# Access Compliance Report

## Public Rights-of-Way

### (Curb Ramps)

Intersection ID: 29186	Main Street: AMUR_CT	Cross Street: JADE_GLEN_DR	Location: E
ADA ID: D85464121D6C	Ramp Type: PerpDiag	Initial Pass/Fail: Fail	Overall Compliance: No
		Severity Score: 12.5

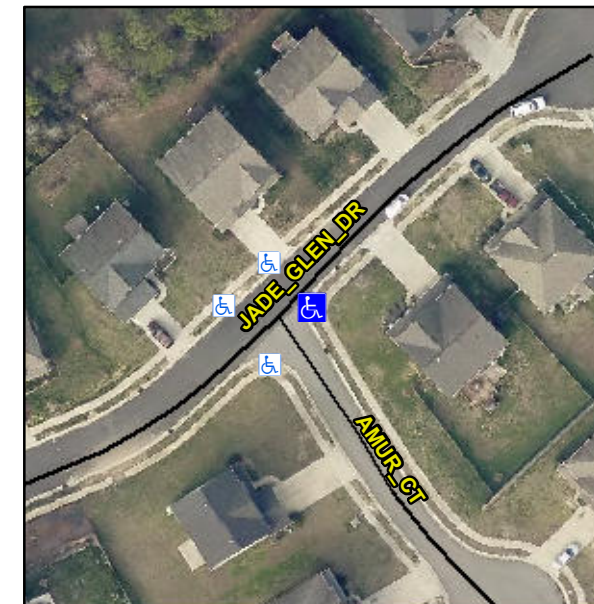
**Not Found, R304.2.2**

Compliance	Description	Data	Compliance	Description	Data
N/A	Ramp Length (in)	51.0	No	Ramp Slope (%)	8.4
Yes	Ramp Width (in)	48.0	Yes	Ramp XSlope (%)	1.2
N/A	Flare Type LT	N/A	N/A	Flare Type RT	N/A
N/A	Flare Slope LT (%)	N/A	N/A	Flare Slope RT (%)	N/A
N/A	Flare Traversable LT?	N/A	N/A	Flare Traversable RT?	N/A
N/A	Landing Length (in)	N/A	N/A	DWS Provided?	N/A
N/A	Landing Width (in)	N/A	N/A	DWS Contrast?	N/A
N/A	Landing Slope (%)	N/A	N/A	DWS Length (in)	N/A
N/A	Landing X Slope (%)	N/A	N/A	DWS Full Width?	N/A
N/A	Landing Curb? (Y/N)	N/A	N/A	DWS Offset (in)	N/A
N/A	Shared Landing?	N/A			
N/A	Gutter Ponding?	N/A	N/A	Gutter Slope (%)	N/A
N/A	Gutter Lip Ht (in)	N/A	N/A	Gutter X Slope (%)	N/A
N/A	Painted X Walk1?	No	N/A	Painted X Walk2?	No
	X Walk 1 Direction	To NW		X Walk 2 Direction	To SW
N/A	X Walk 1 Width (in)	N/A	N/A	X Walk 2 Width (in)	N/A
	X Walk 1 Slope (%)	0.4		X Walk 2 Slope (%)	1.0
	X Walk 1 X Slope (%)	0.8		X Walk 2 X Slope (%)	1.5

**Remove & Replace Curb Ramp With Two New Directional Ramps or Equivalent.**
